Architectural Review Board

Staff Report (ID # 9957)

Report Type:	Subcommittee Items	Meeting Date: 2/7/2019
Summary Title:	3128 El Camino Real: Subcommittee Review of Trellis, Landscaping, Benches and Building Color	
Title:	3128 El Camino Real [17PLN-00462]: Subcommittee Review of a Previously Approved Project That was Conditioned to Return With Project Changes Related to Trellis Design, Landscaping, Benches and Building Color. Environmental Assessment: Exempt From the Provisions of the California Environmental Quality Act (CEQA) in Accordance With Guideline Section 15303 (New Construction). Zoning District: CS (Commercial Service). For More Information Contact the Project Planner Adam Petersen at apetersen@m-group.us	
From:	Jonathan Lait

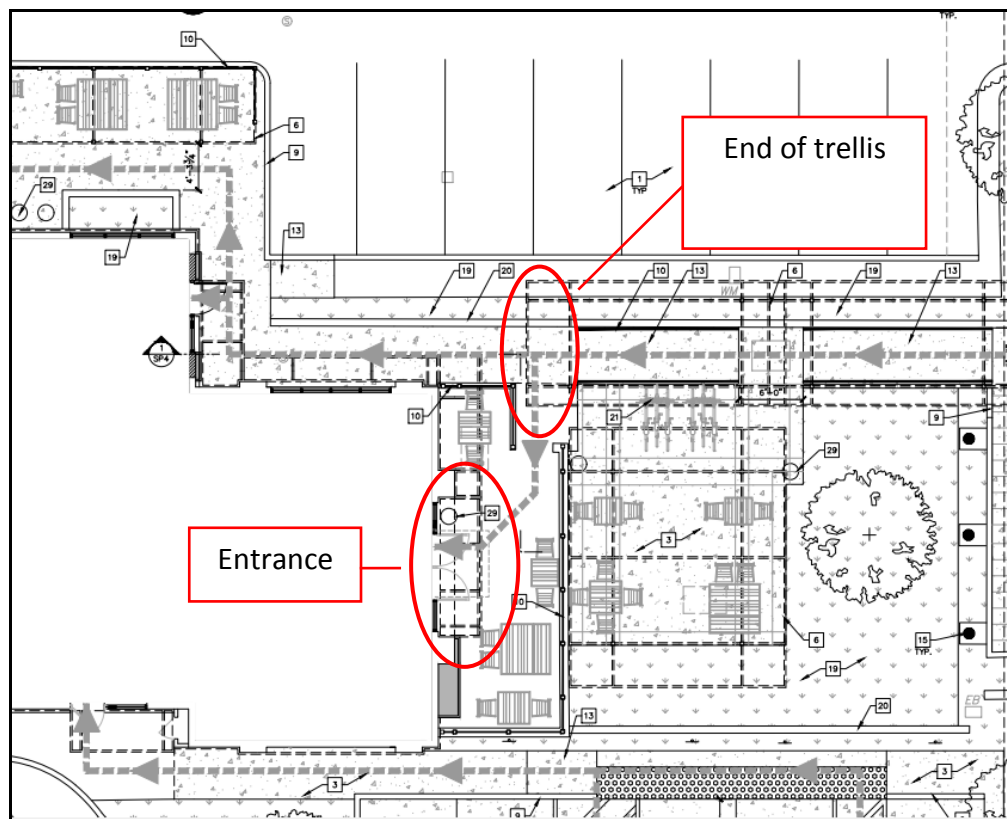
- The applicant has revised the landscape plan and now proposes Muhlenbergia Rigens (deer grass) behind the brick wall. With a wall height of 36-inches, the Muhlenbergia Rigens will exceed the height of the wall because the plant grows to a height of four feet (4') to five feet (5'). The applicant has also revised the landscape plan by including California blue sage, blue grama, and monkey flower in the area between the patio dining and sidewalk. The landscape plan, stamped by a licensed Registered Landscape Architect, indicates plants are regional, indigenous, and drought resistant.

The applicant proposes colored concrete paving beneath the brick walls. The colored concrete paving is proposed to be Scofield integral color SG 160-4 brick red, with a smooth finish. Staff would appreciate the ARB's comments on this color choice.
